**FINAL DRAINAGE REPORT FOR
COPPER CHASE AT STERLING RANCH
EL PASO COUNTY, COLORADO**

JANUARY 2022

Project #09-014
PCD Project # SF XX-XXX

PUDSP222

STORM 1 NETWORK LAYOUT

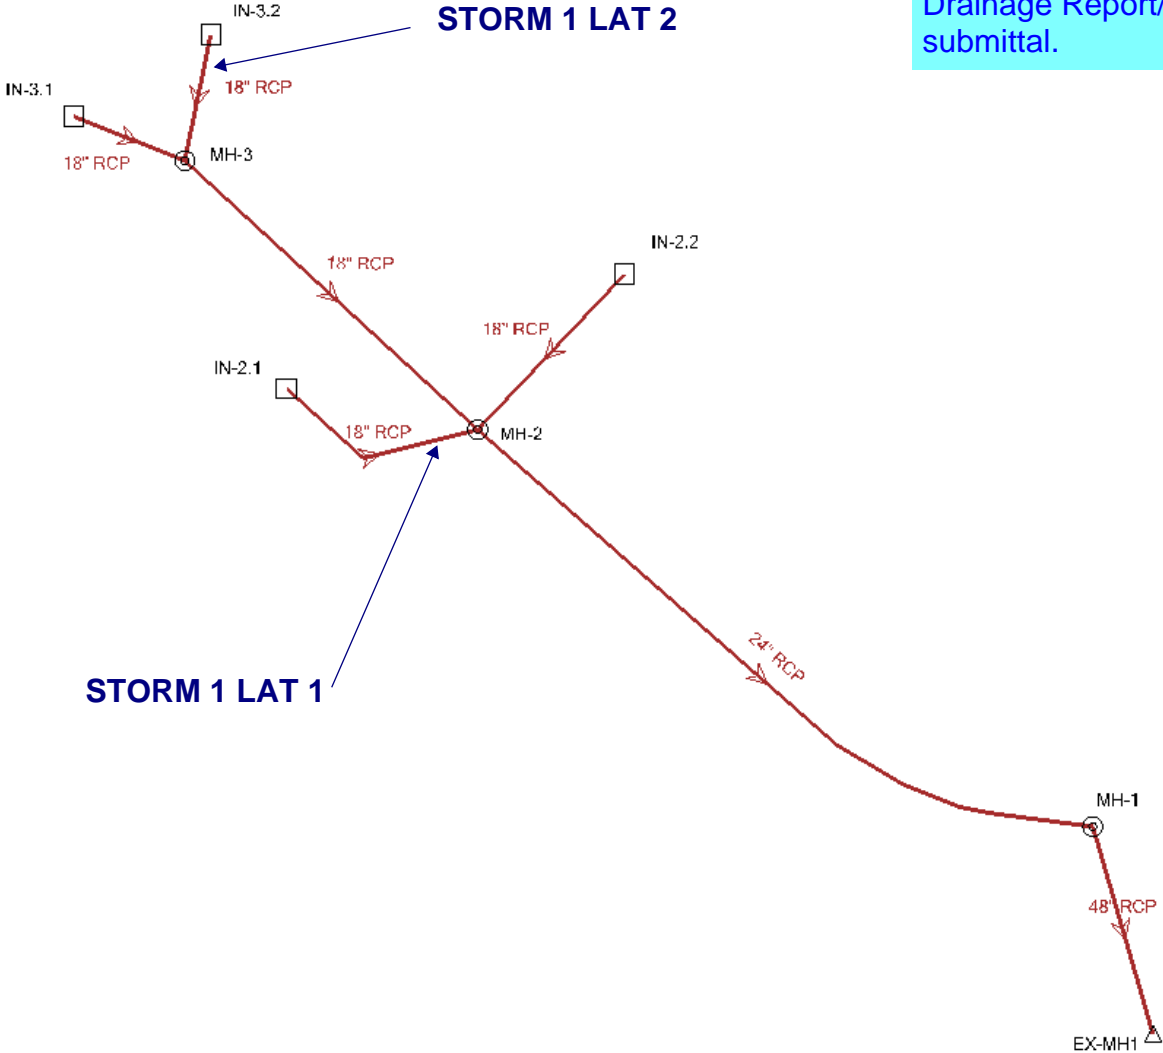
Cursory review only was done on storm sewer design. Final review will be performed with Final Drainage Report/Final Plat submittal.

COPPER CHASE EXISTING DRAINAGE MAP

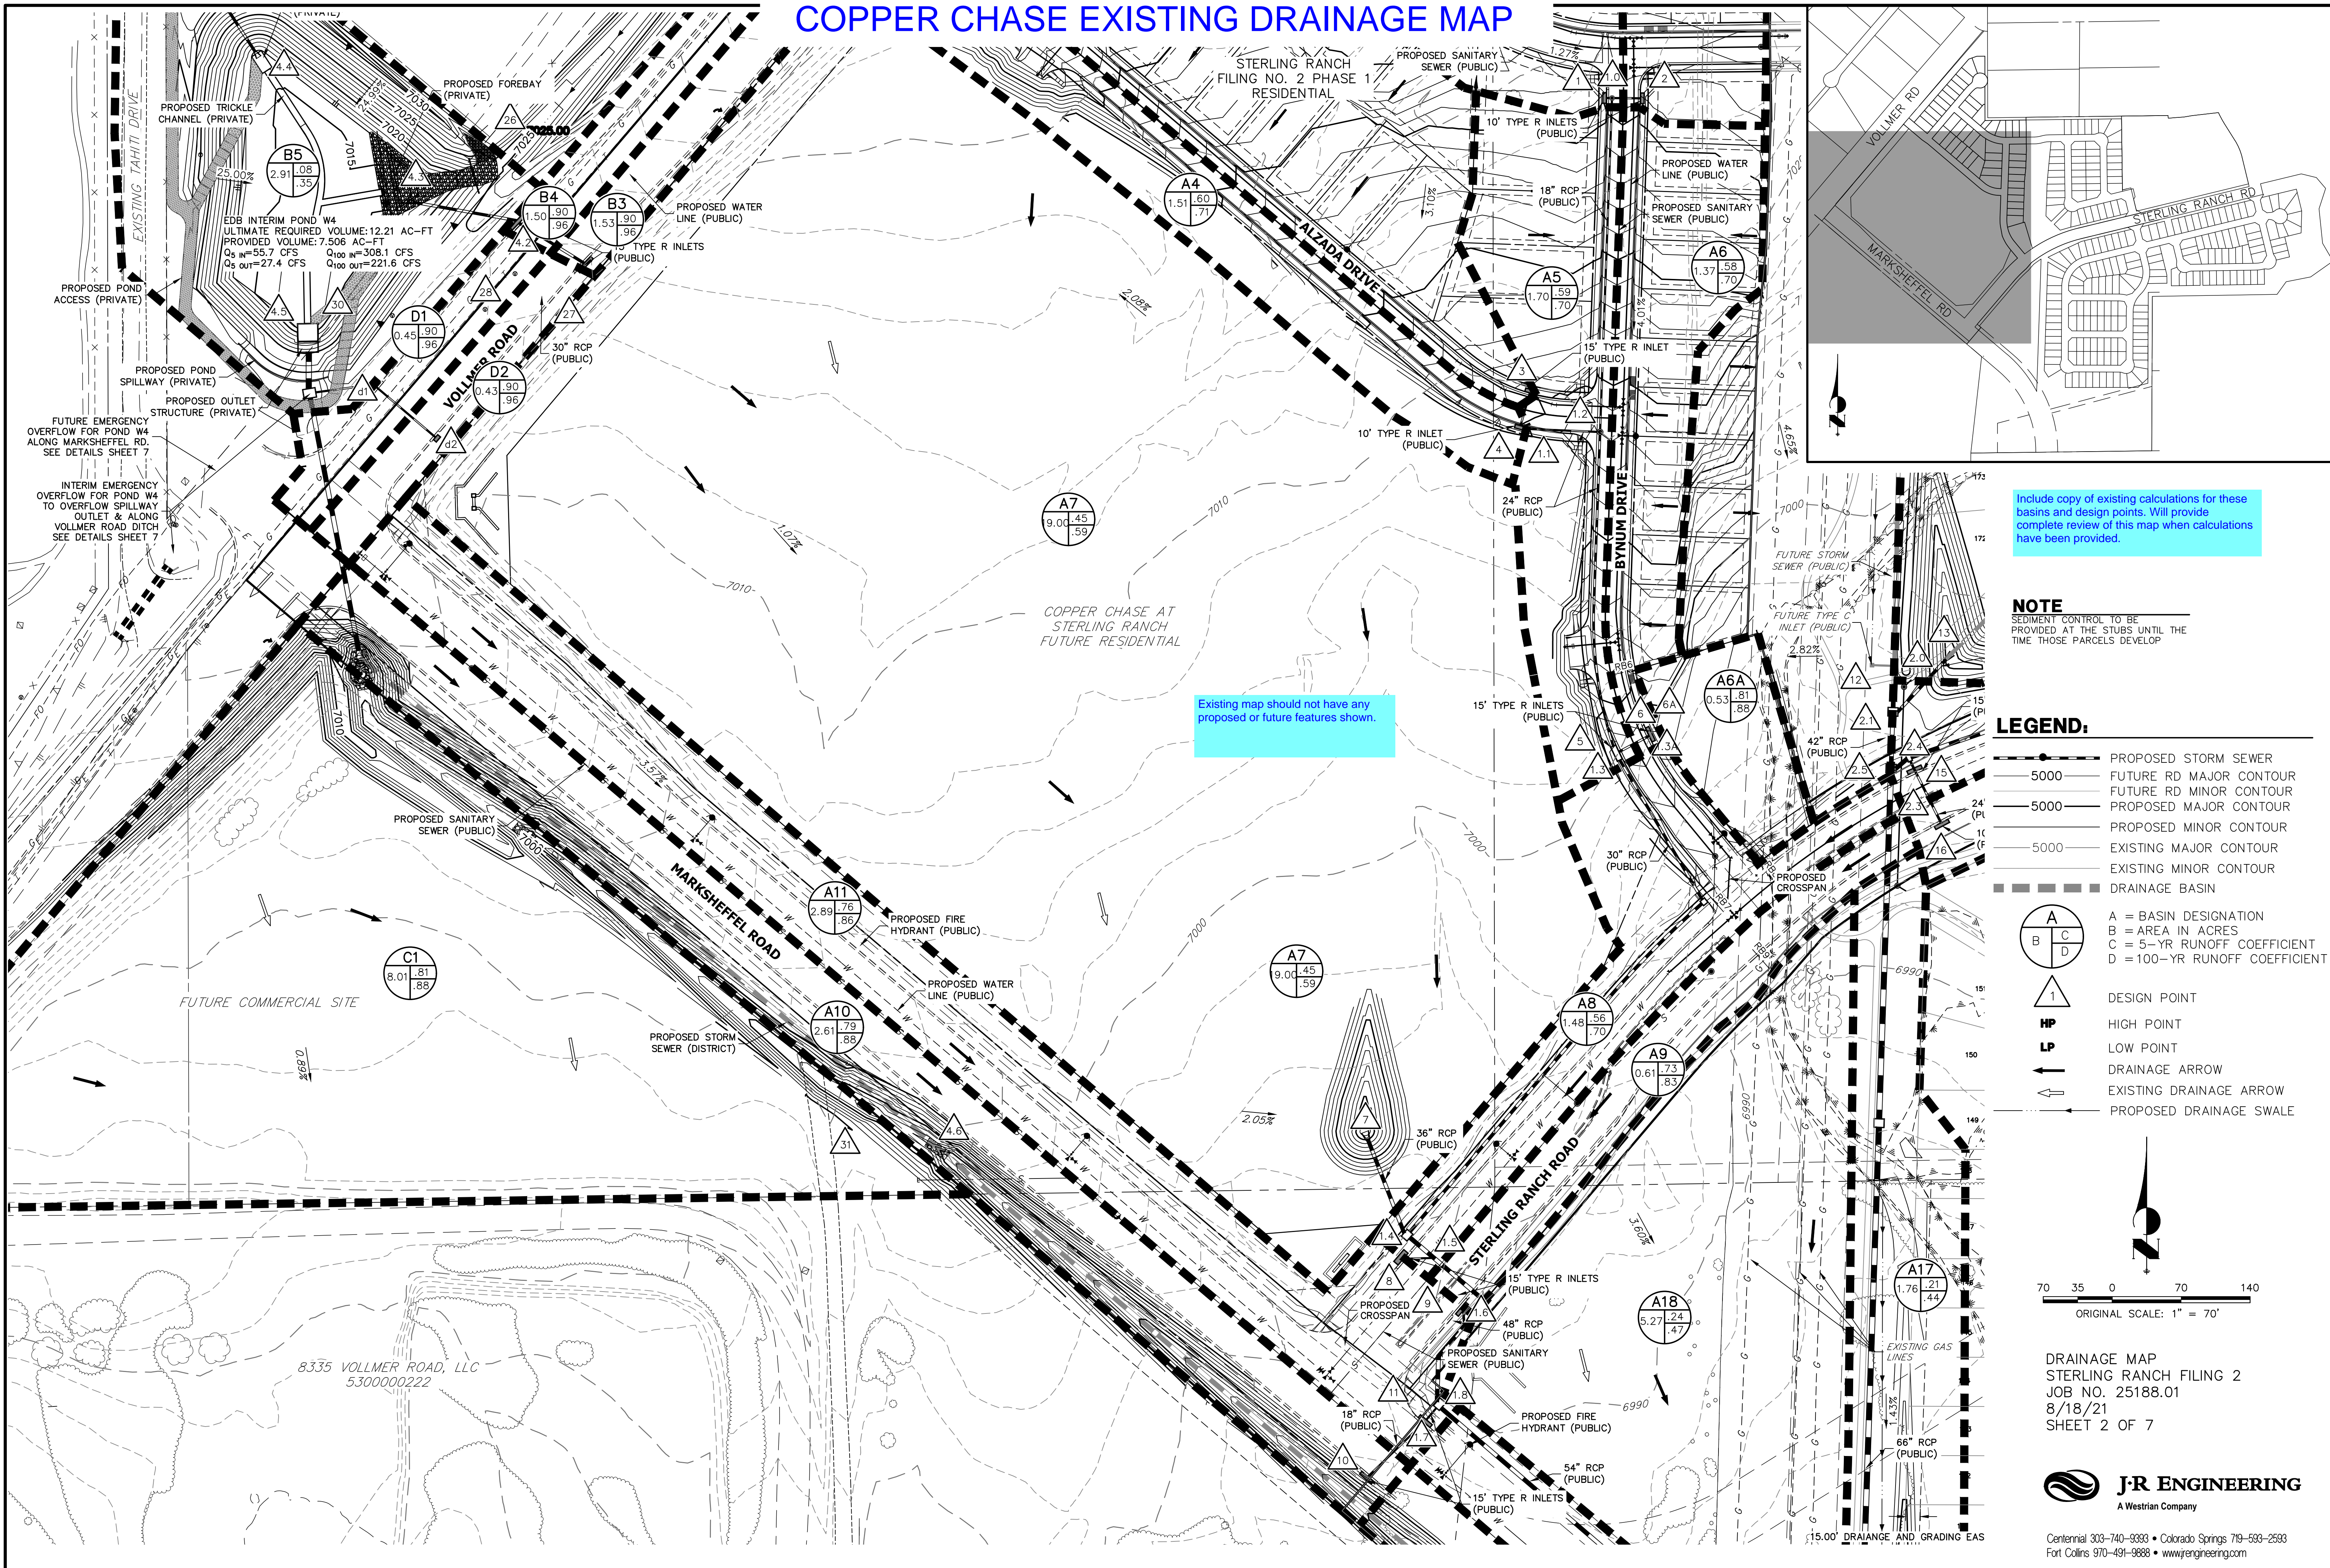
Existing map should not have any proposed or future features shown.

Include copy of existing calculations for these basins and design points. Will provide complete review of this map when calculations have been provided.

PROPOSED DRAINAGE MAP

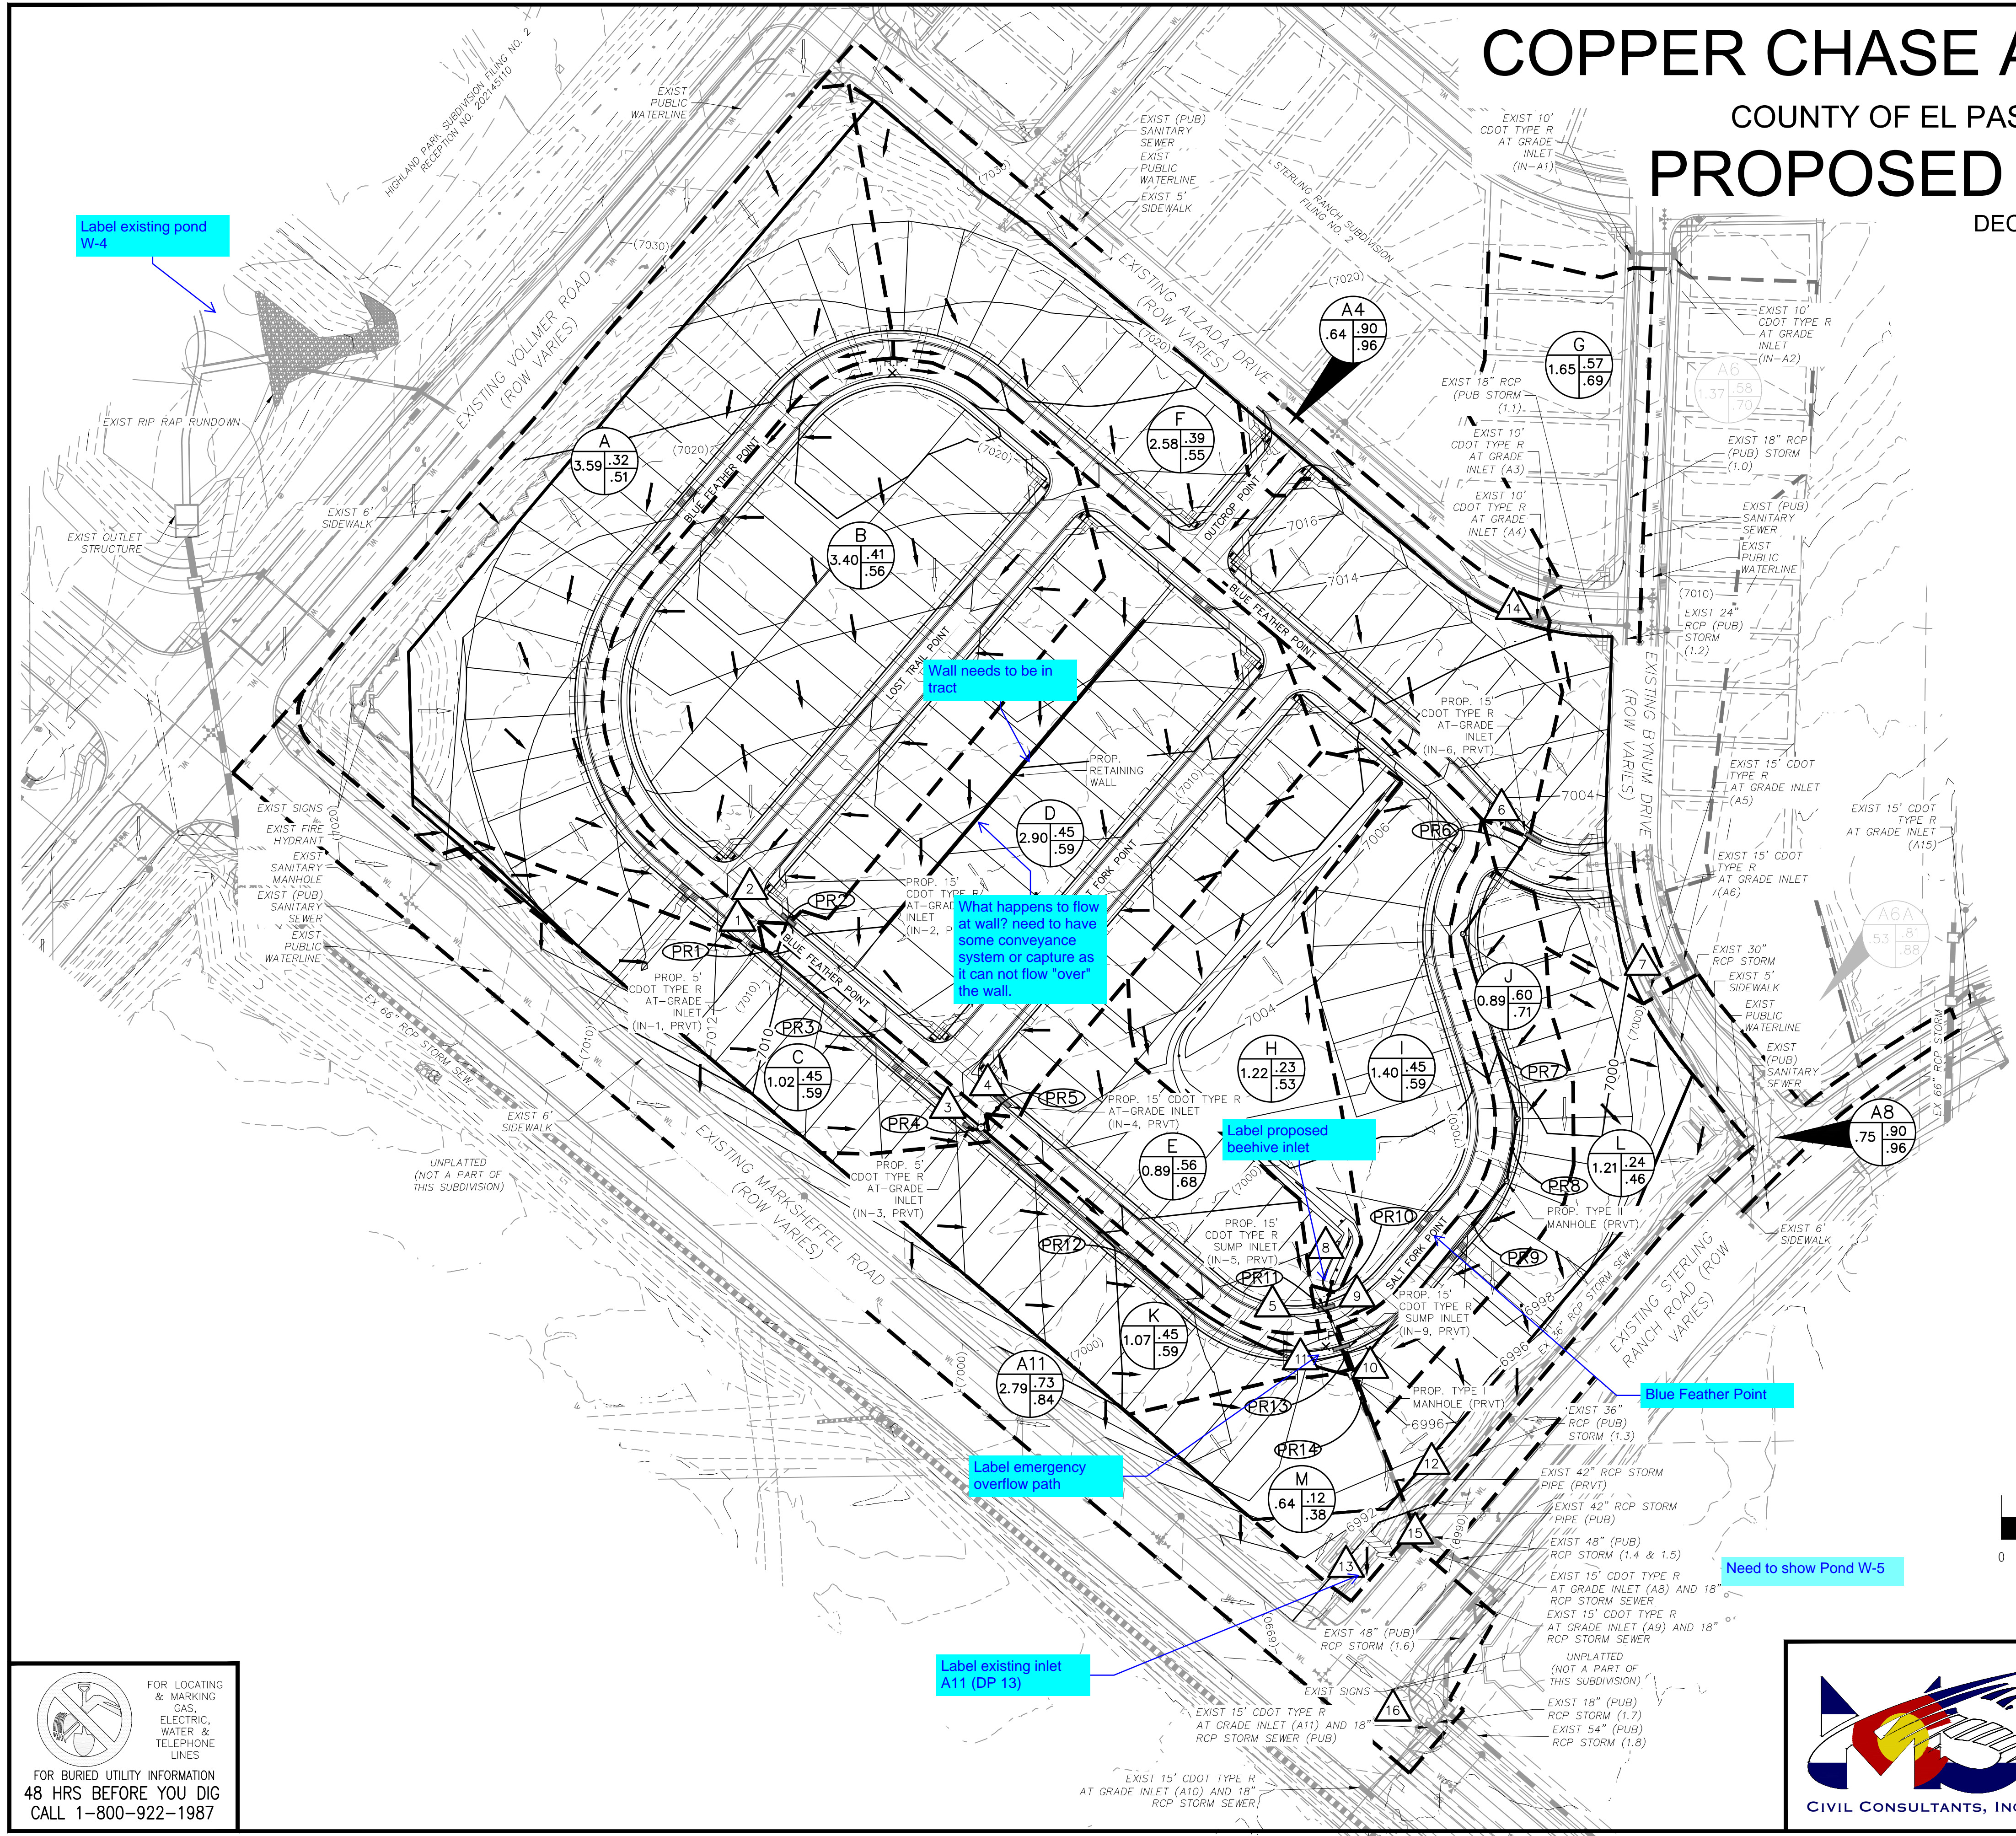
Emergency overflow arrows not shown on map. Please add/turn on.

label on proposed drainage map

Need to show Pond W-5
